Maine Yankee

Subject: Response to NRC Request for Additional Information For Exemption From Financial Protection Requirement Limits; (TAC Nos. MA0659 and MA0660)

ATTACHMENT
RESPONSE TO REQUEST FOR ADDITIONAL INFORMATION REGARDING ASSESSMENT OF THE LOSS OF
WATER FROM THE SPENT FUEL POOL AT A DECOMMISSIONED PLANT

HIGH DENSITY SPENT
FULL RACK LAYOUT
FOR A TWO REGION POOL
MADE UTILITY SERVICES
MADE VINCENT ATOMIC POWER CO
PROJECT 3.0000000000000000
DATE 03-4-63
BY 1A-1

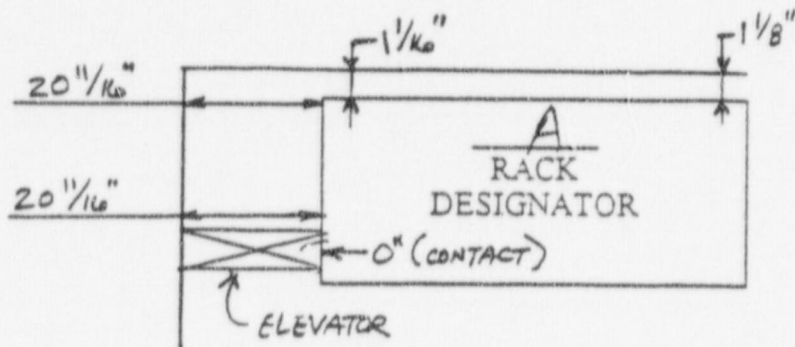
- (a) Top View Provide a top view of the pool. Please include, but not limited to, the lengths and widths of pool, clearances/space around the edge of the pool, layout of the modules, open space, and cask loading area (if applicable).

See Drawing 03443-EM-1A-1 and Rack Final Positioning Measurement Drawings for Racks A, B, C, D, E, F, G, H, I, J, M, N, O, P, S, T, U, V, W, X, Y, AA, BB, CC, DD, EE

FIGURE 6-1
BASIC FUEL STORAGE CELL

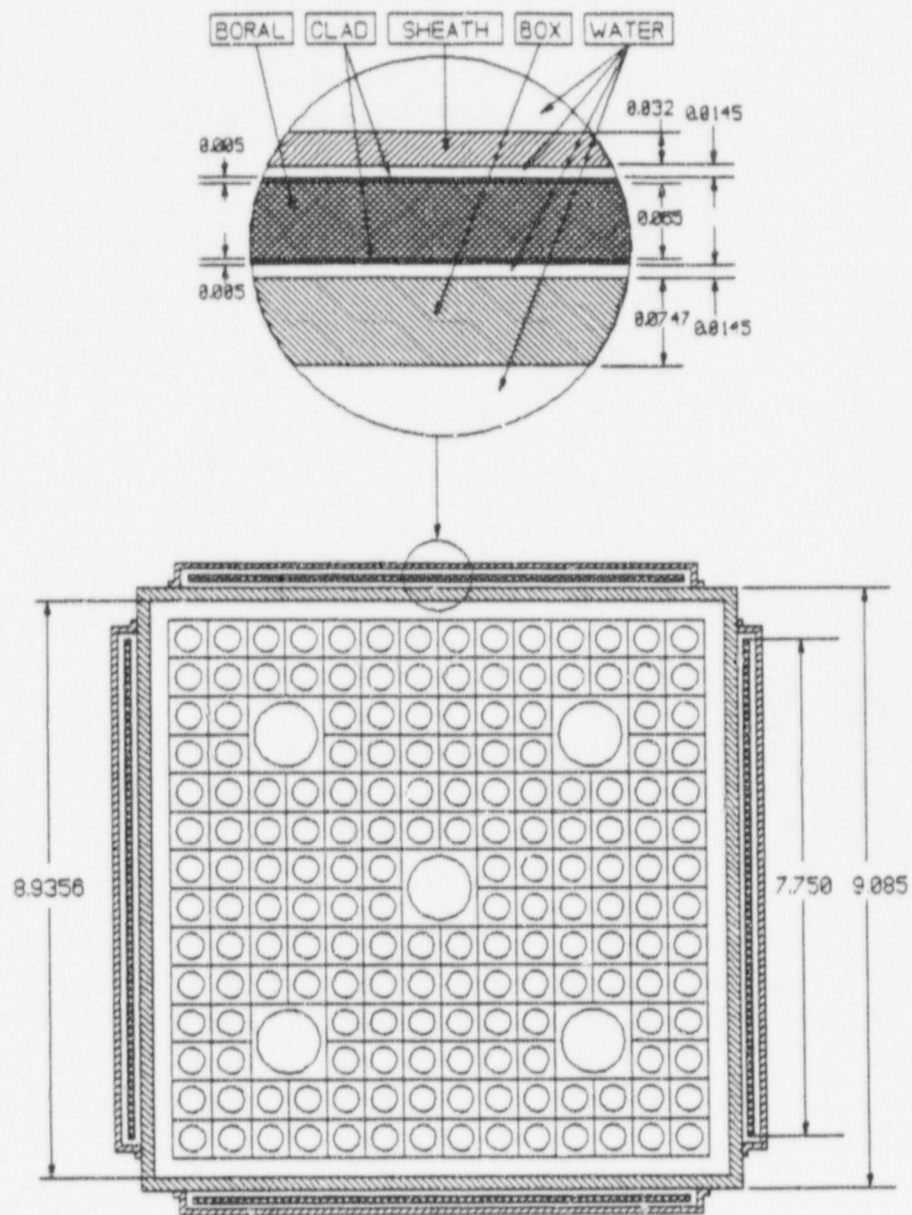
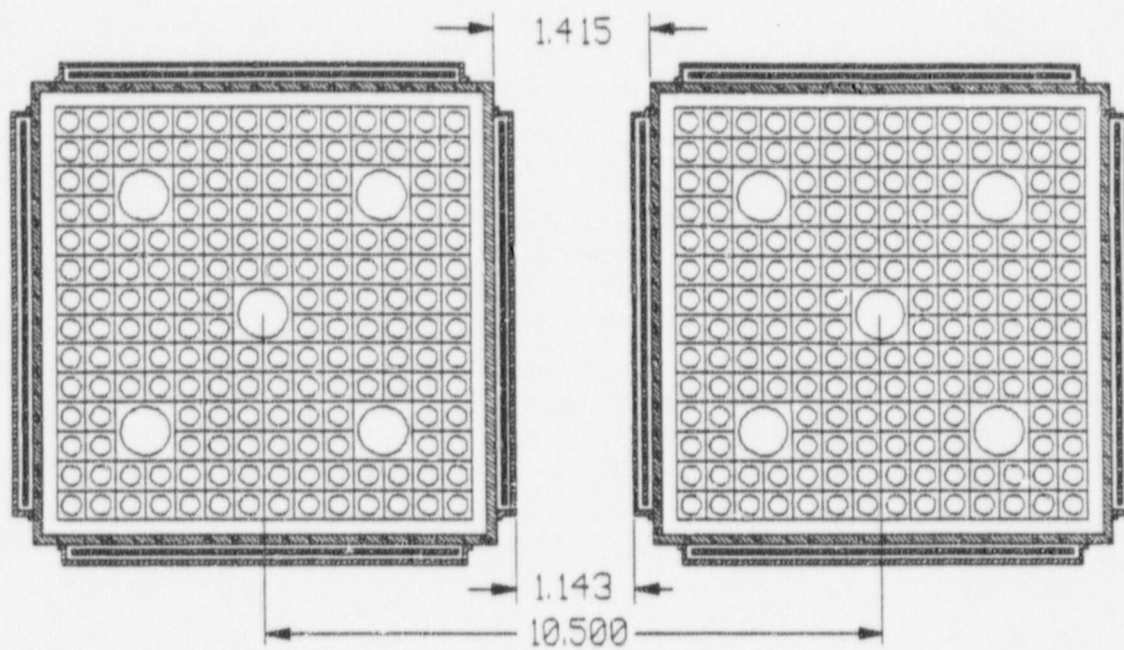
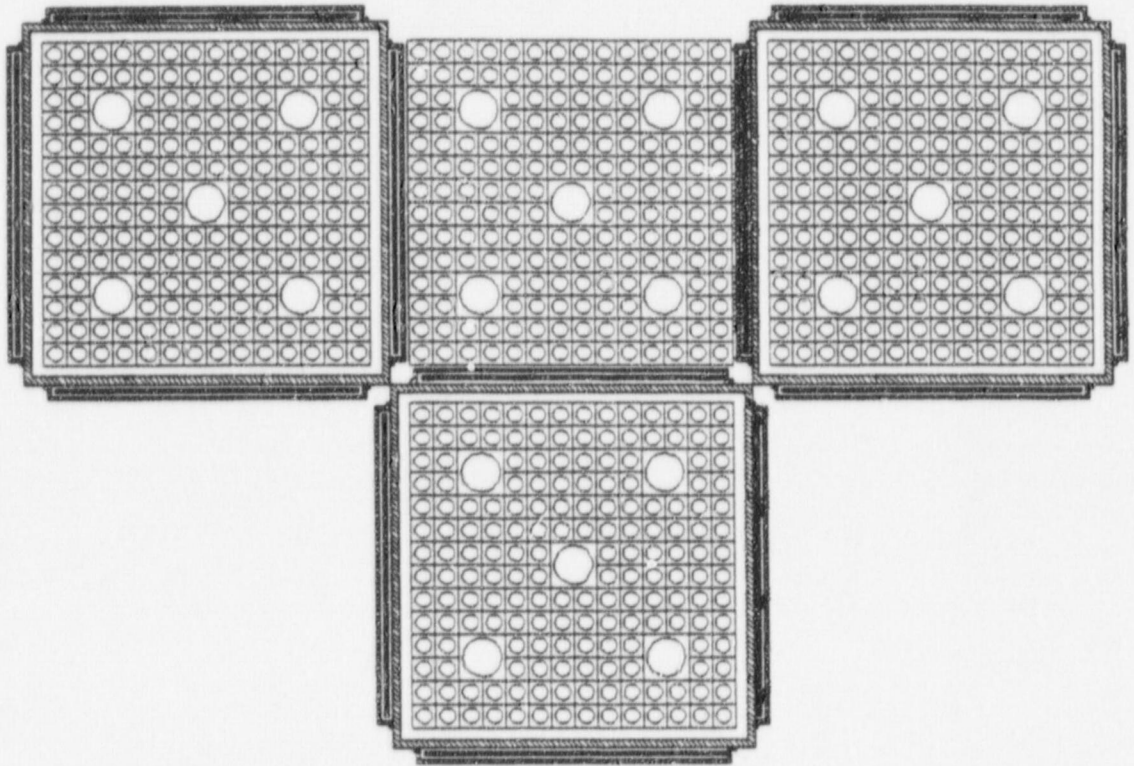
- (b) Top view Provide a top view of a cell showing the wall thickness and cell dimensions.

Cell Wall: 304L stainless steel Thickness: 0.0747 in.
 Sheath covering BORAL™: 304L stainless steel Thickness: 0.032 in.
 BORAL™ Dimensions: Width: 7.75 ±0.0625 in.
 Length: 140 ±0.0625 in.
 Thickness: 0.075 ±0.004 in.
 BORAL™: 0.065 in.
 Aluminum: 2 x 0.005 in.

See attached Figure 6-1, 6-2, and 6-3 from MYAPC Letter to USNRC dated January 25, 1993, (MN-93-09)

Spent Fuel Pool Elevation Drawing

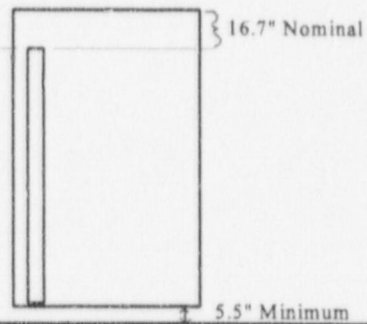
- (c) Side view Provide an elevation drawing of the fuel racks from the pool floor to the top of the racks. Please include, but not limited to, the space between the floor and the bottom of the spent fuel rack, the active fuel height, the distance from the top of the active fuel to the top of the cell.

See Spent Fuel Pool Elevation Drawing

22.578 El. Top of Highest Rack
21.184' El. Top of Active Fuel (Highest)
